Airstream Service Bulletin

Bulletin Number: 196

Product Line: Model Year 2023 Interstate E1 (19' & 24') and Atlas E1 Touring Coaches

Subject: Power Center Circuit Breaker Relocation

Incorrect

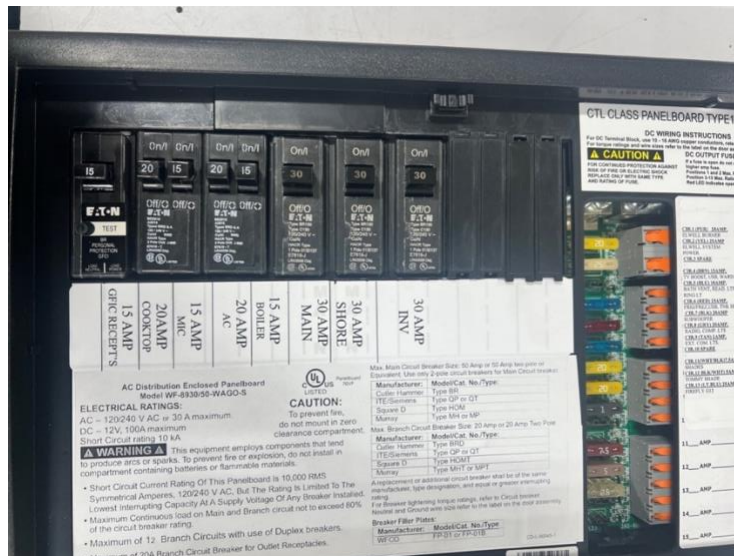
1. Locate the Power Center and verify that the breakers need to be relocated. If the 30 Amp INV and 30 Amp SHORE breakers are positioned to the right, separated from the other breakers by blank plates as shown in the first image below, they will need to be moved. If all the breakers are next to each other, with no plates between them, as shown in the second image below, this procedure is not needed.

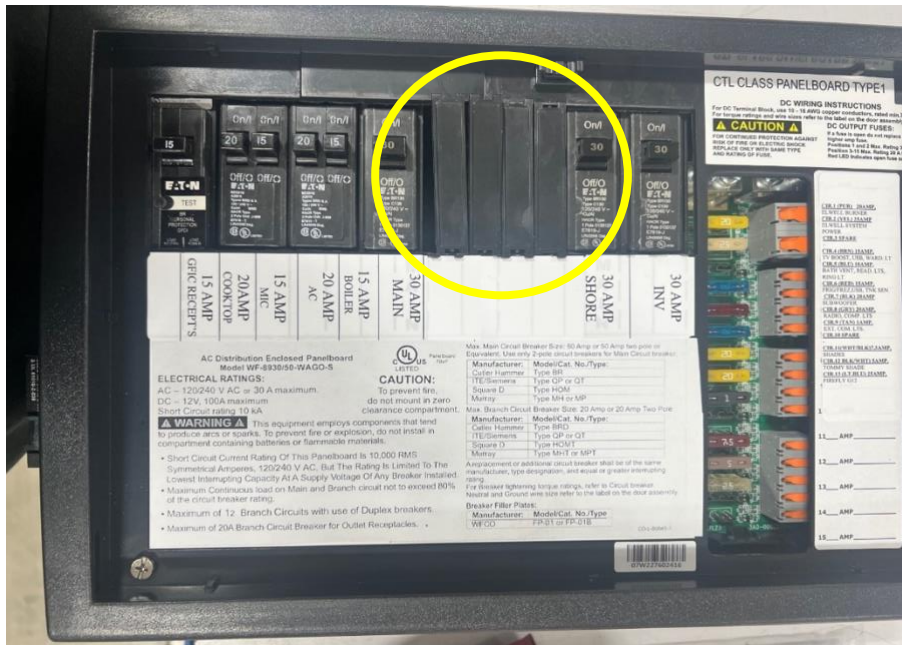
2. After determining that the breakers need relocated, remove the two hold down screws to remove the trim ring and gain access to the breakers.

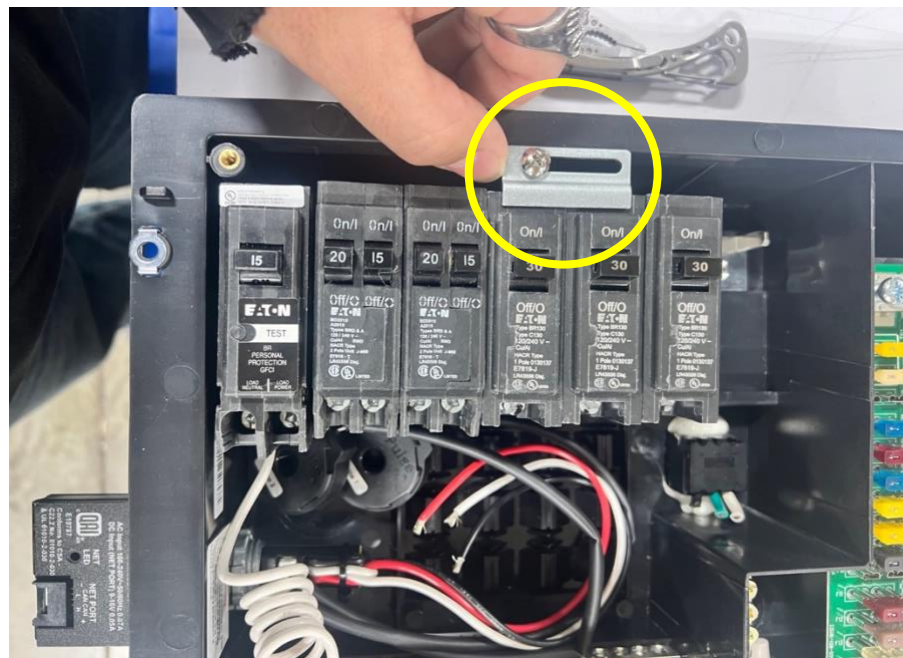
4. With the trim ring and blank plates removed, move the 30 Amp INV and 30 Amp SHORE breakers down, so they are directly beside the 30 Amp MAIN breaker.

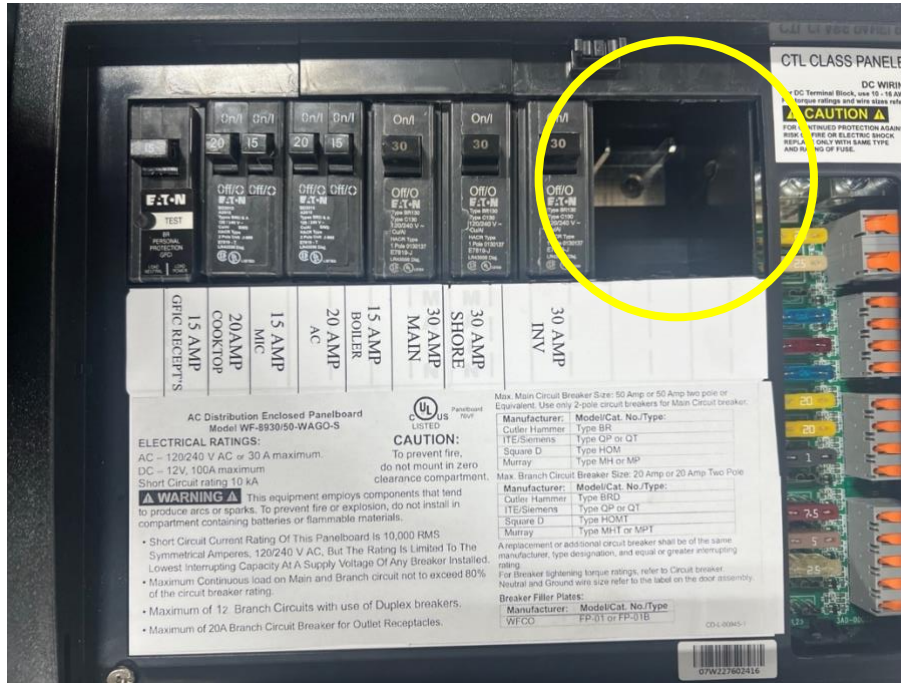
5. Relocate the metal lockdown bracket, so that it covers both the 30 Amp MAIN and 30 Amp SHORE breakers, and secure the screw.

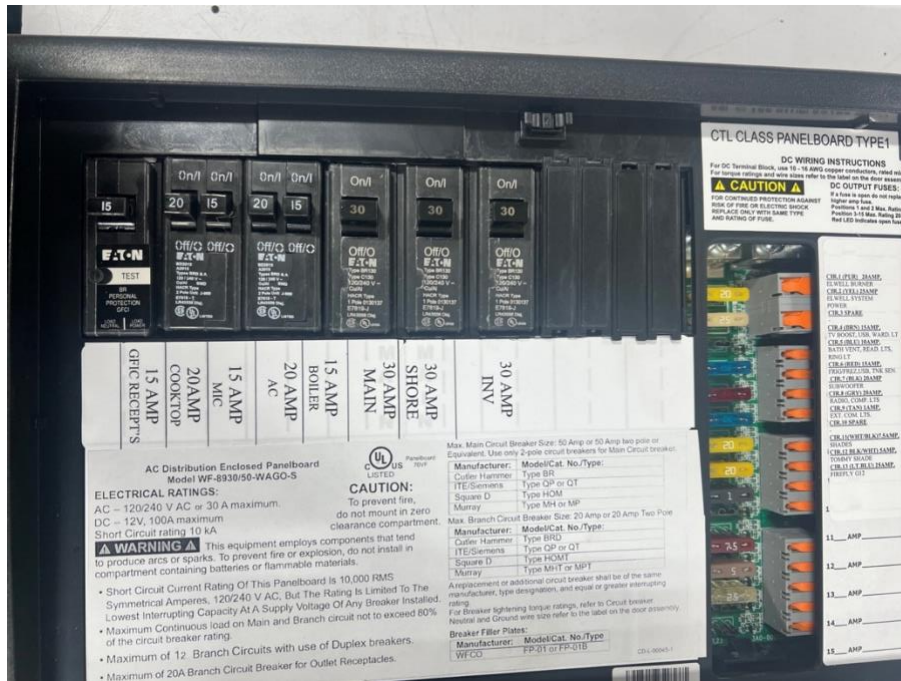
- With the breakers relocated, reinstall the trim ring and tighten the two hold down screws. There should now be an empty space to the right of the breakers.
